A02 - 171

# Service Information

### CHANGES DURING PRODUCTION P2002 100W VCD MODULE - MAINS BOARD

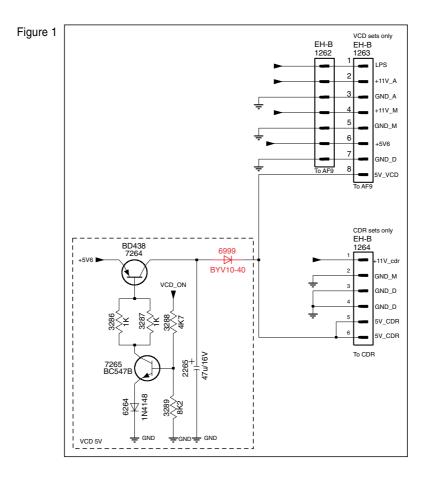
\*From production week 0218 onwards new Mains & Mains Socket pc boards is introduced due to process improvement. The board can be recognized by the printing mark 12NC - 3139 113 34822. For this reason new pc board layout is enclosed.
